NEW FIRE STATION: ENGINE CO. 268 / LADDER CO. 137

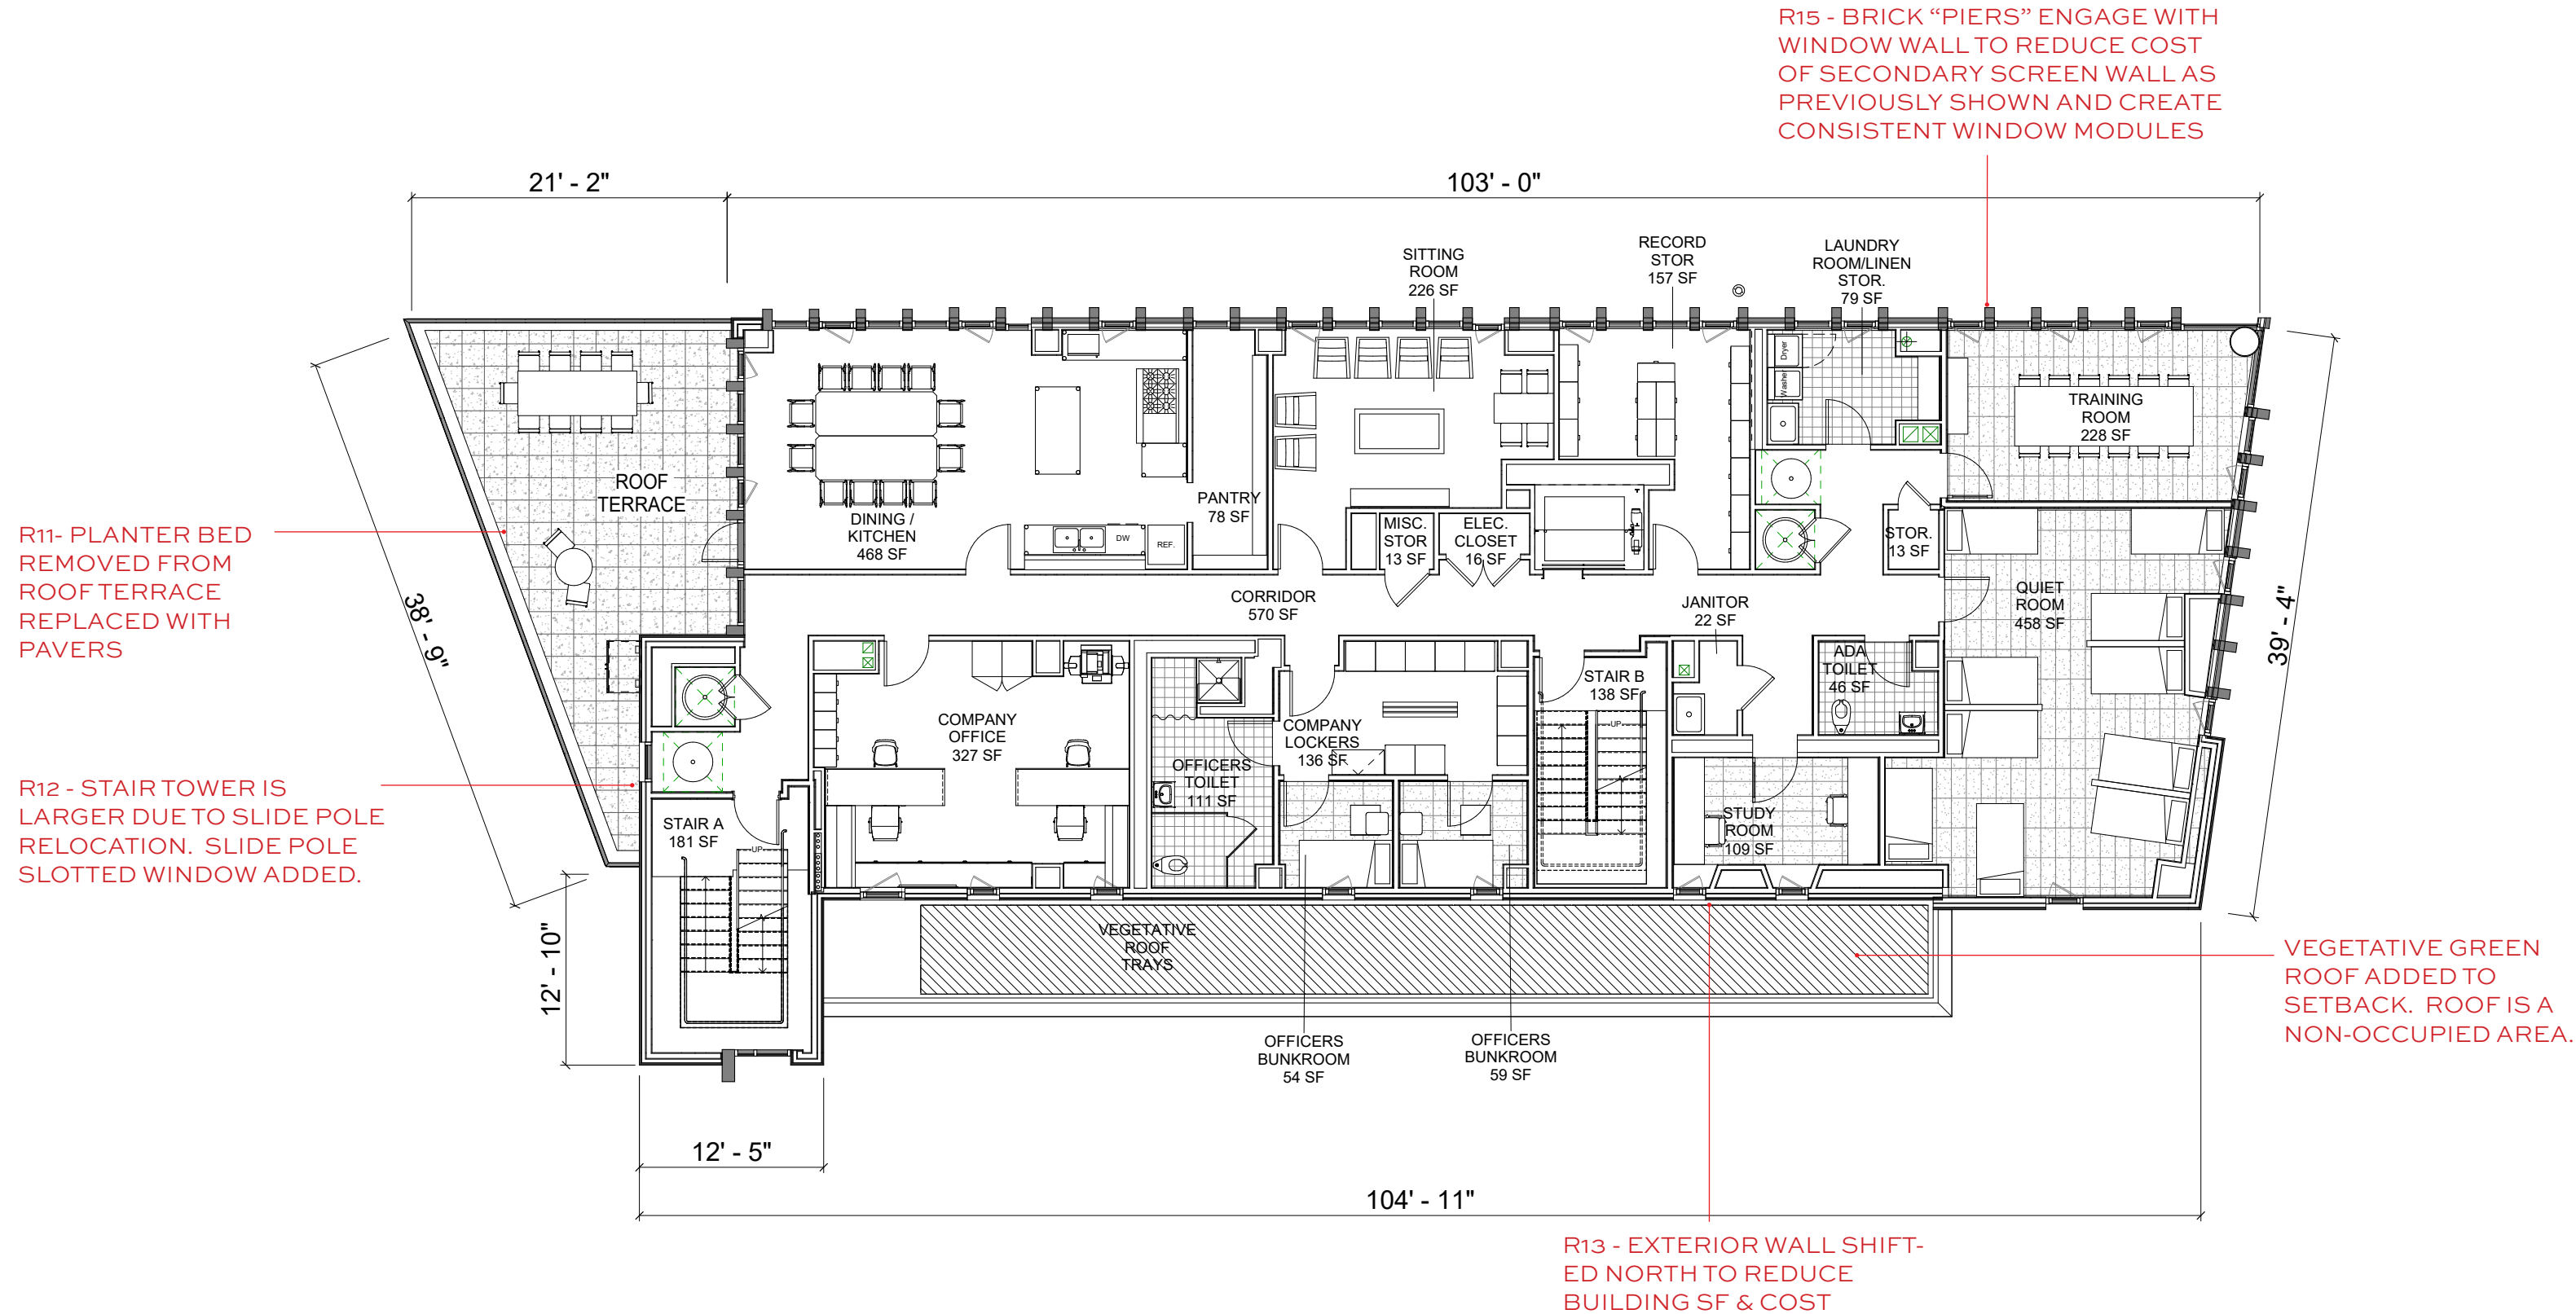
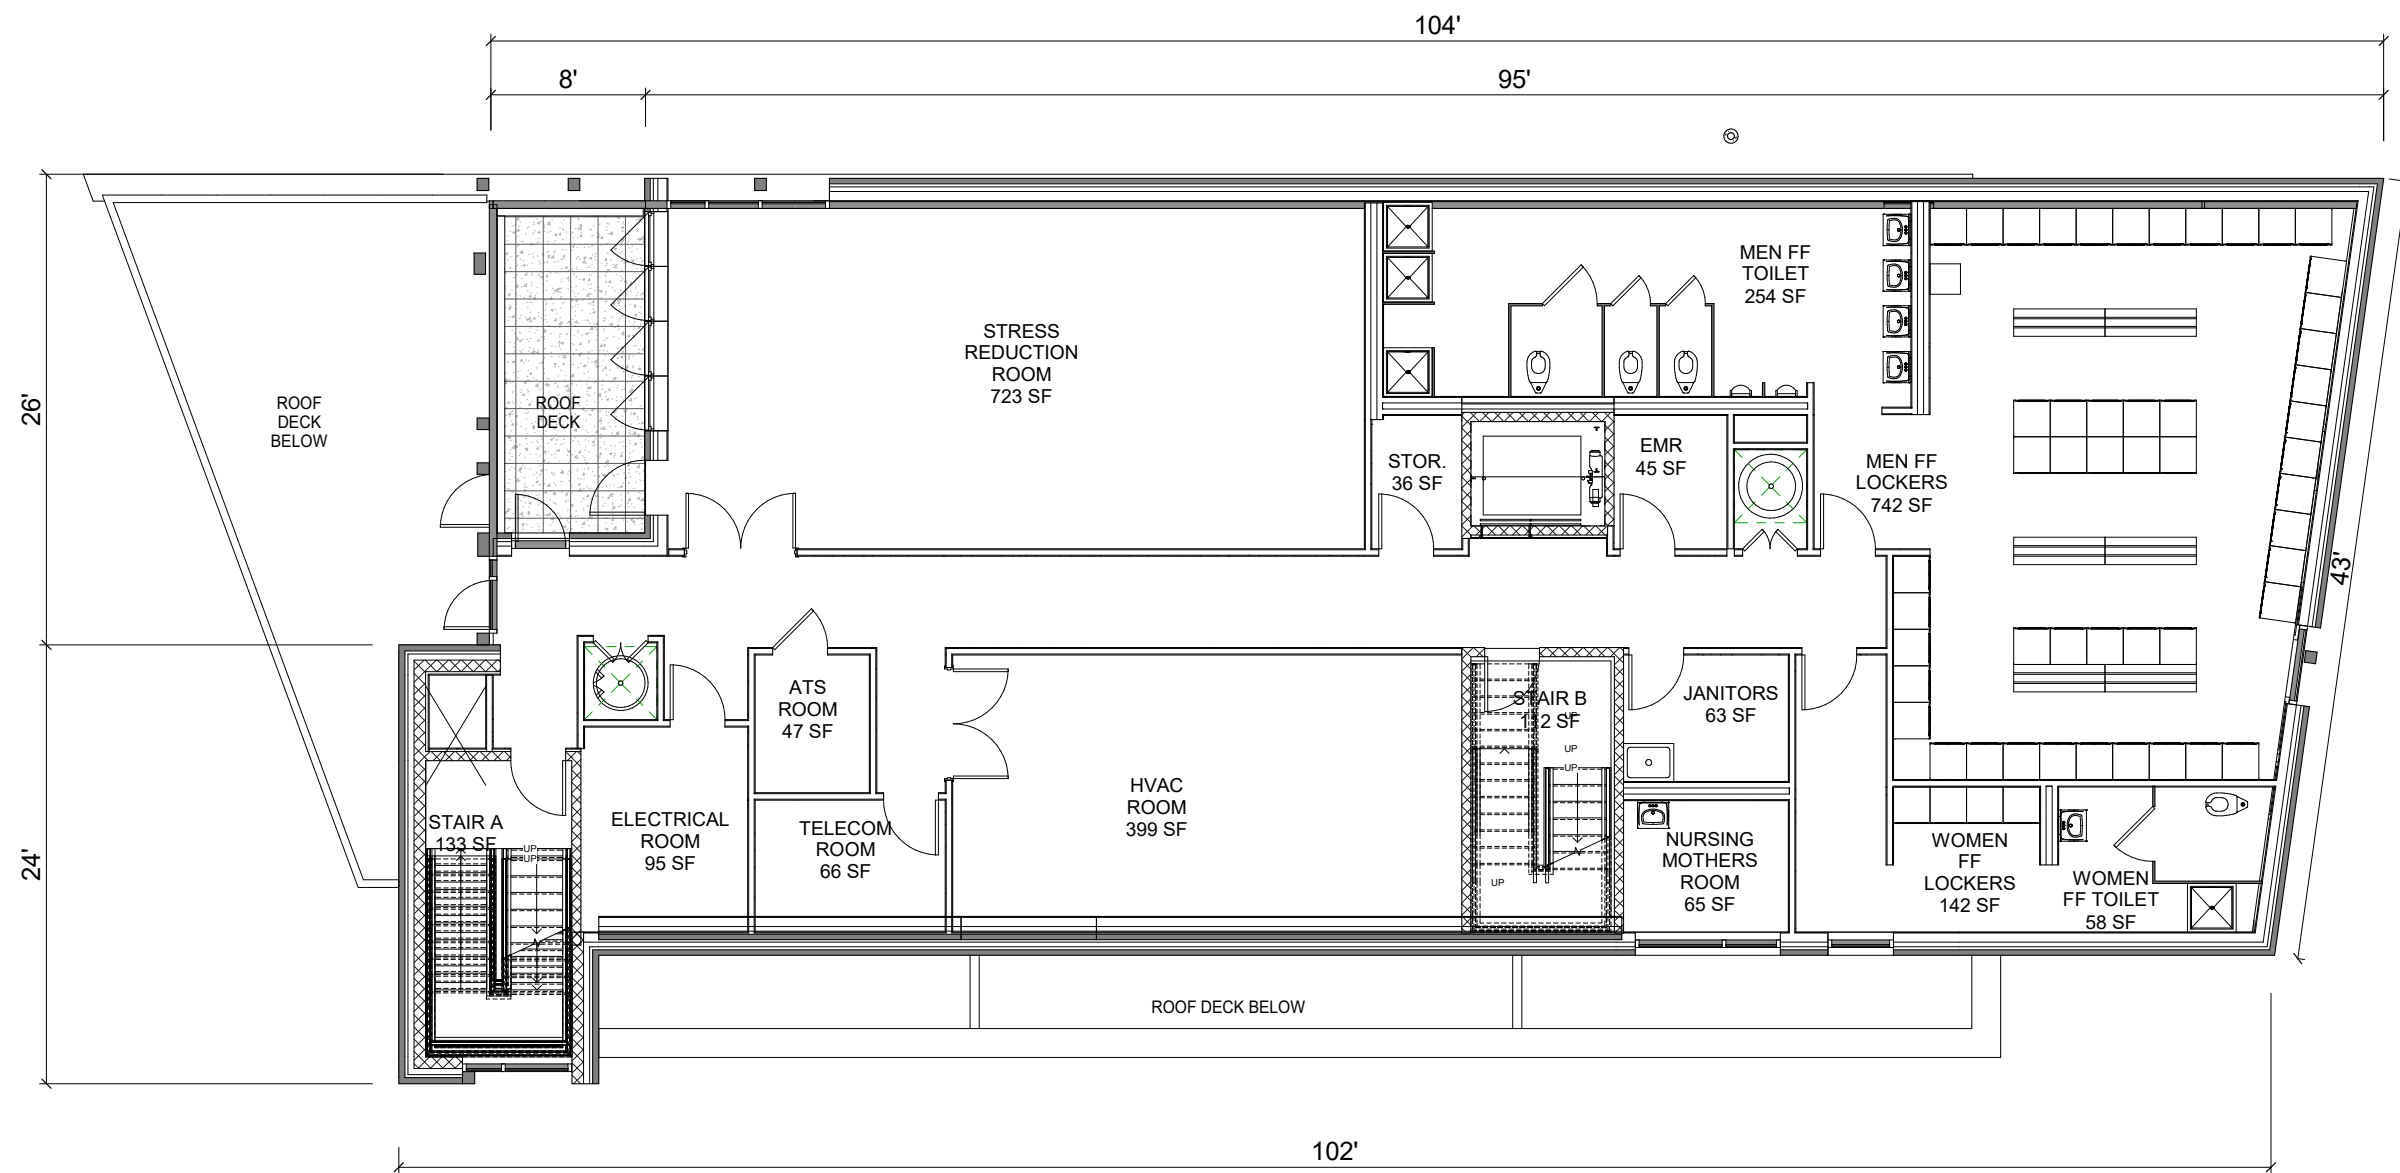
R7 - EGRESS DOOR
REMOVED DUE TO
STAIR REMOVAL

R8 - LOUVERS
REMOVED AND
REPLACED WITH
SOLID BRICK WALL

R10 - WINDOWS ADDED TO
HOUSEWATCH & SLIDE POLE
ABOVE ENTRANCE

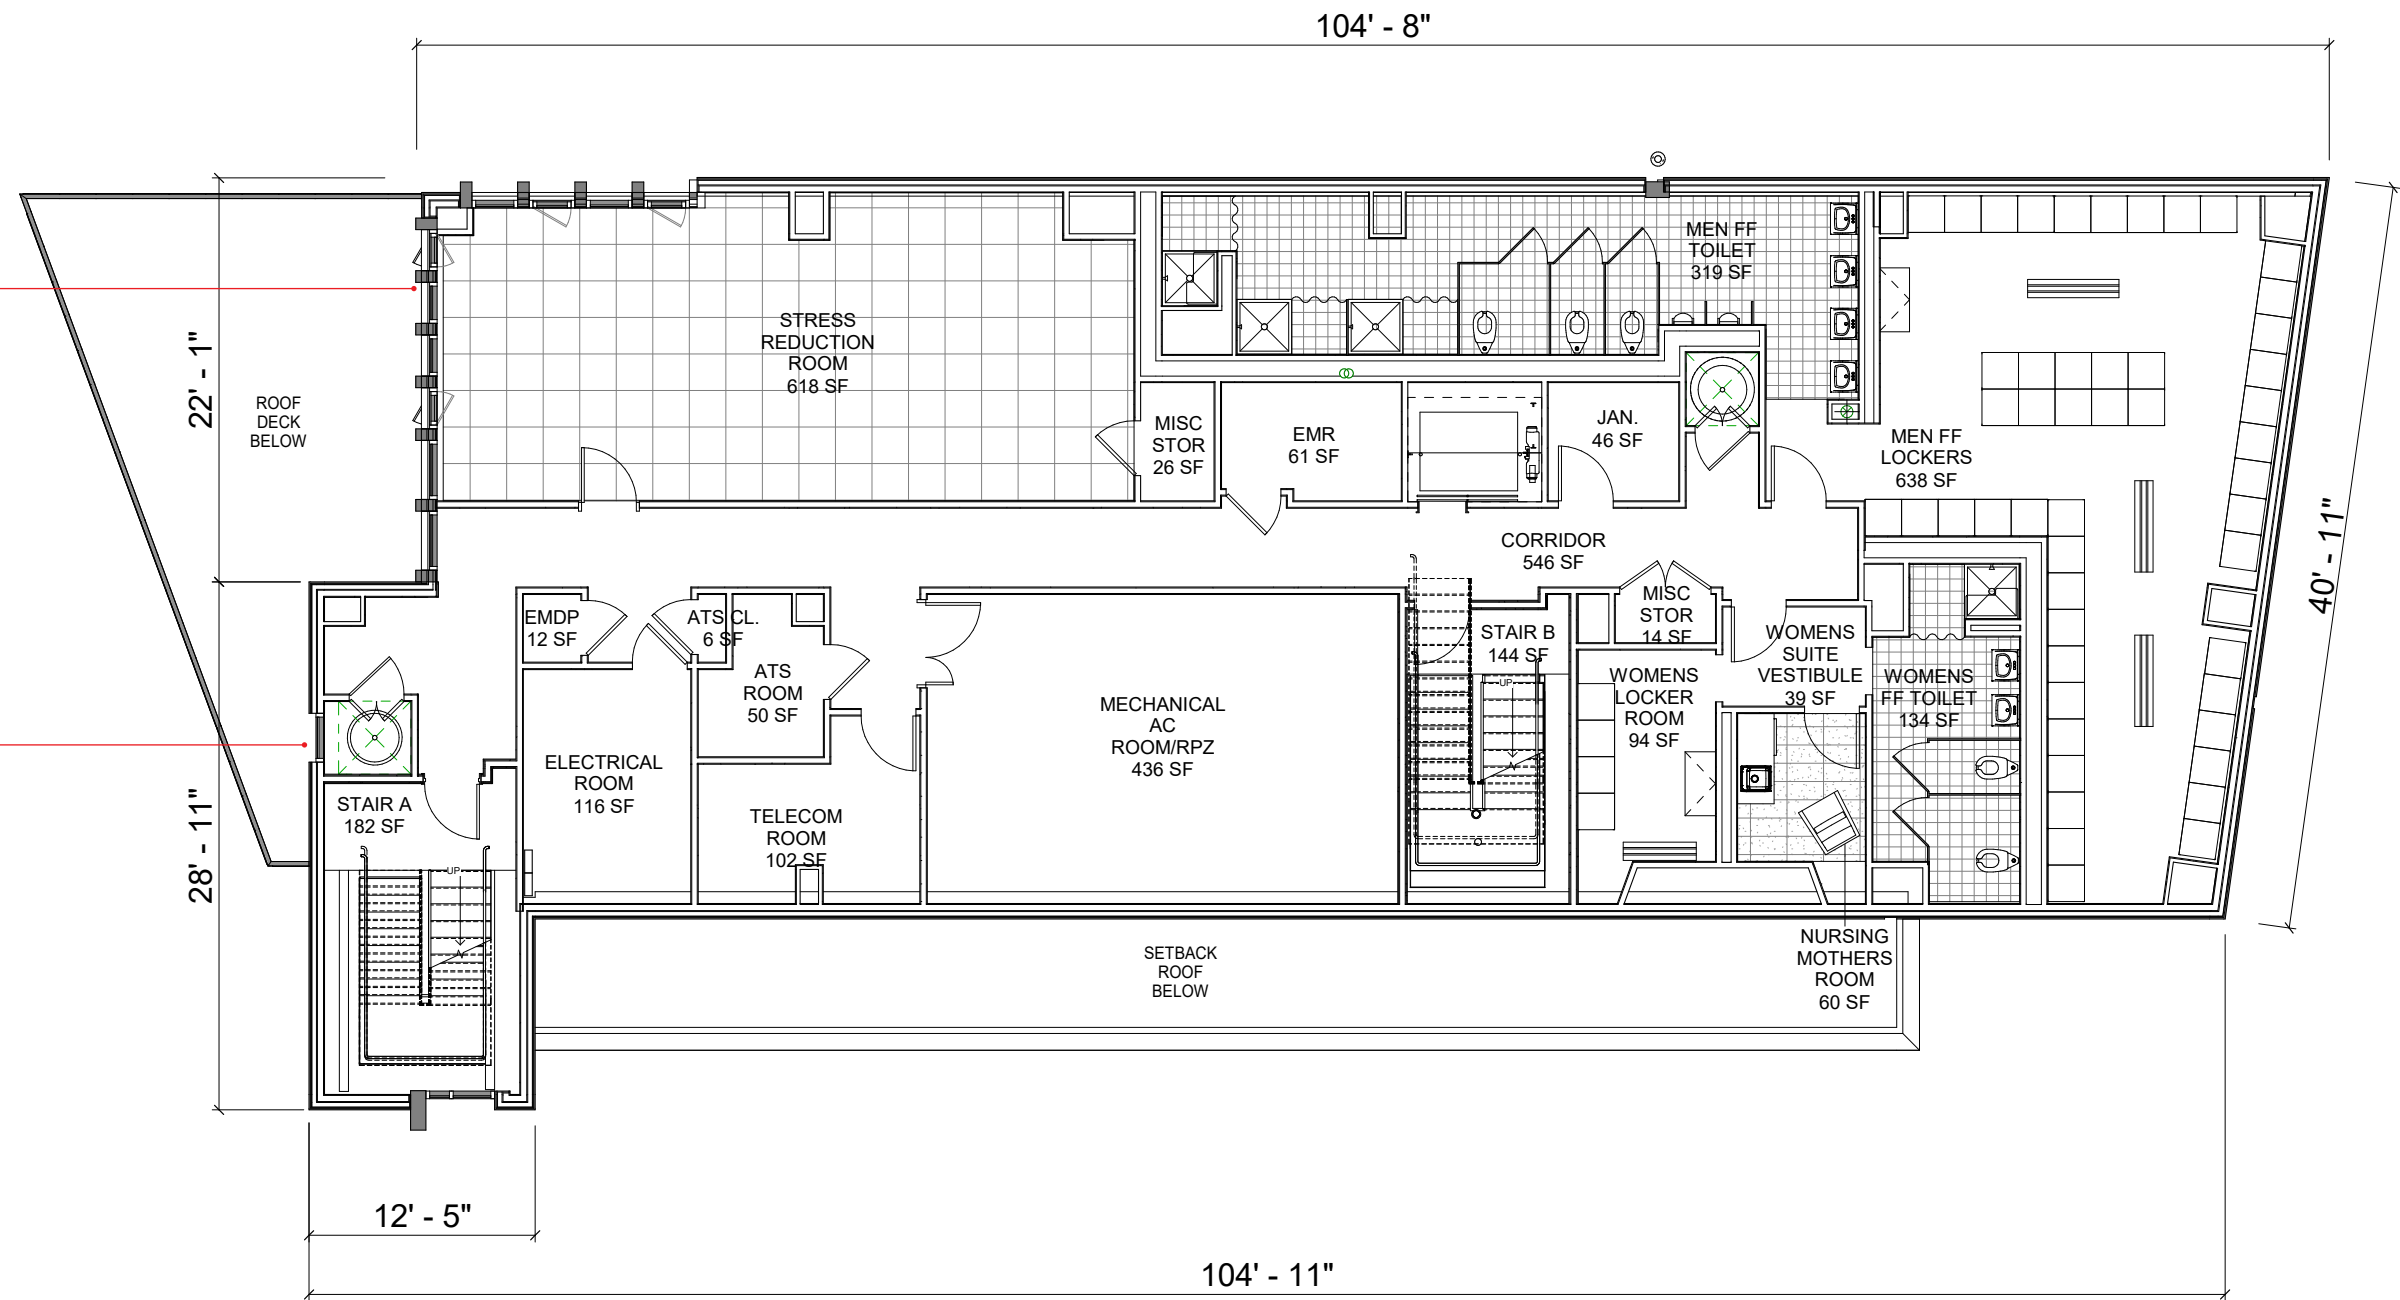
R9 - WINDOWS
ADDED TO
TACTICAL
TRAINING OFFICE
& CLASSROOM

R16 - ROOF DECK
REMOVED, AREA ADDED
TO STRESS REDUCTION
ROOM

R17 - SLIDE POLE SLOTTED
WINDOW ADDED TO STAIR
TOWER

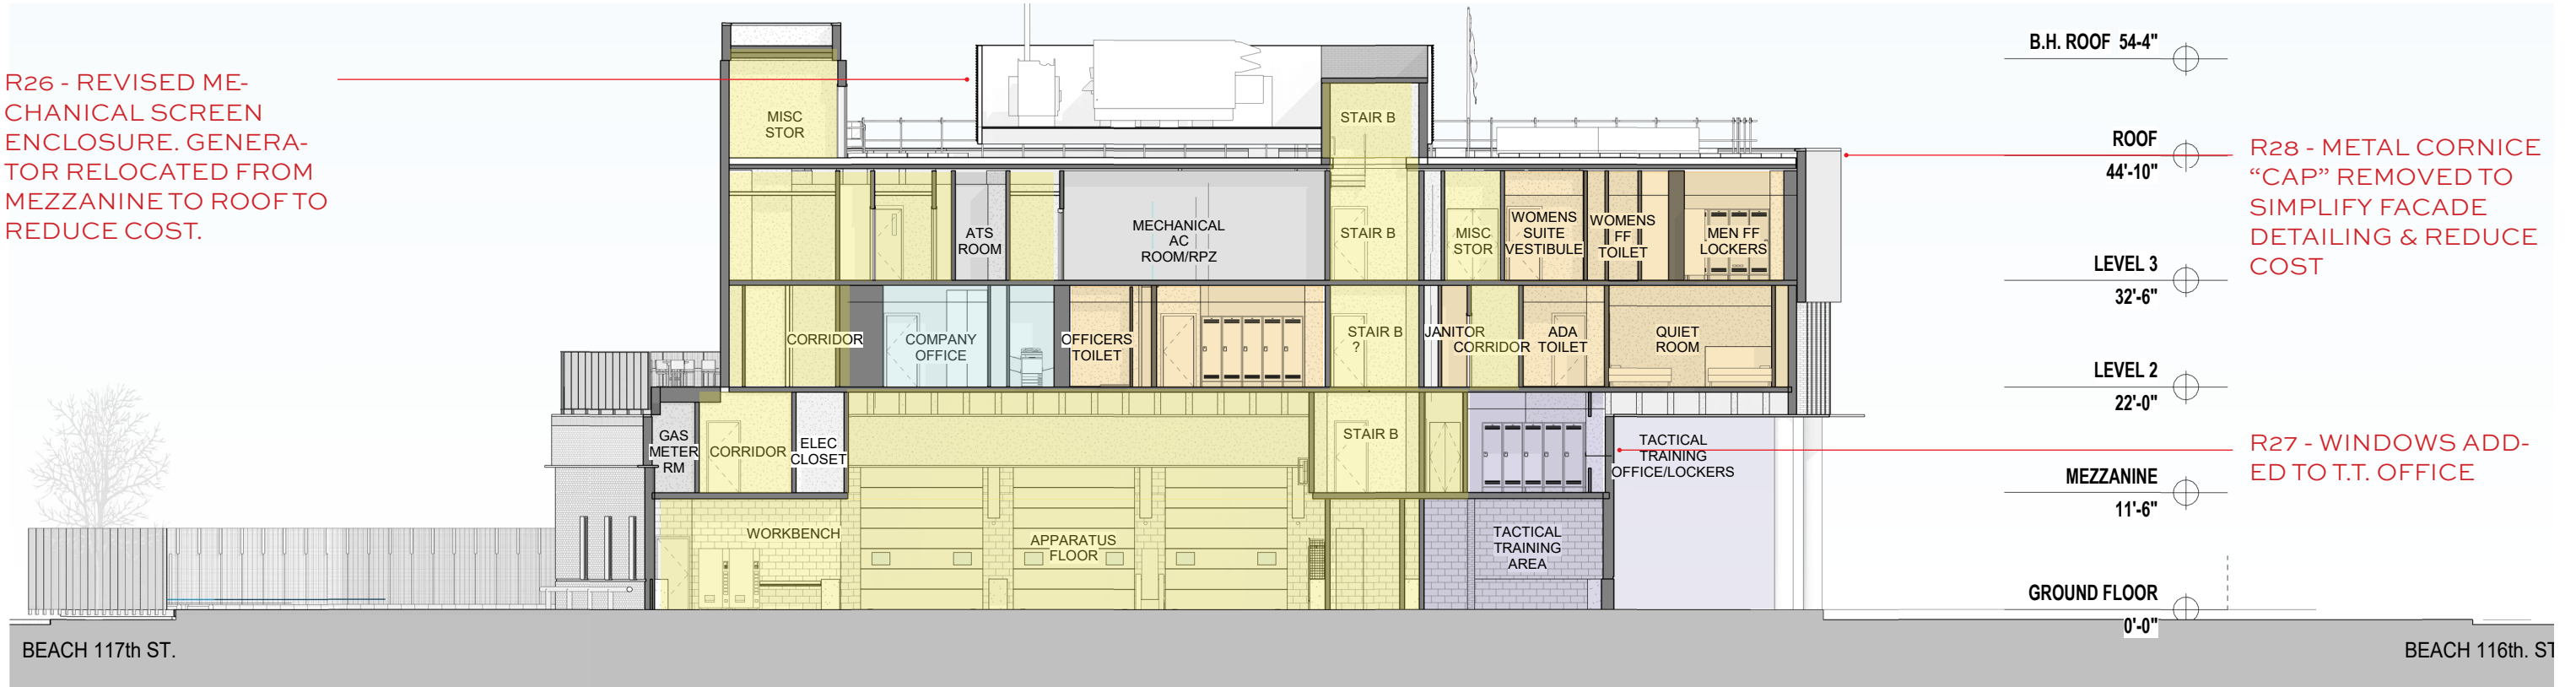
R25 - REVISED MECHANICAL SCREEN ENCLOSURE. GENERATOR RELOCATED FROM MEZZANINE TO ROOF TO REDUCE COST.

R26 - REVISED MECHANICAL SCREEN ENCLOSURE. GENERATOR RELOCATED FROM MEZZANINE TO ROOF TO REDUCE COST.

R28 - METAL CORNICE "CAP" REMOVED TO SIMPLIFY FACADE DETAILING & REDUCE COST

R27 - WINDOWS ADDED TO T.T. OFFICE
